CUNO-330.2
10/764,717

PATENT
June 27, 2005

REMARKS

Fig. 3

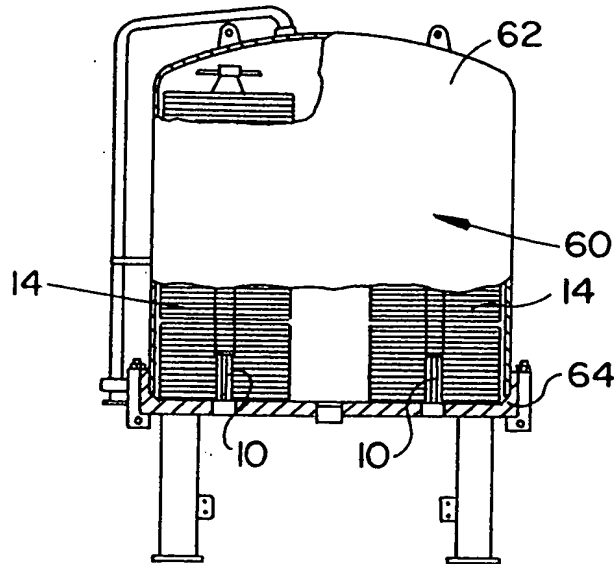
Please replace Sheet 2/6 (Figure 3) and sheet 6/6 (Figure 9C) with the new Sheets 2/6 and 6/6 enclosed herewith. A copy of the replacement sheets 2/6 and 6/6 is being sent to the official draftsman concurrently herewith.
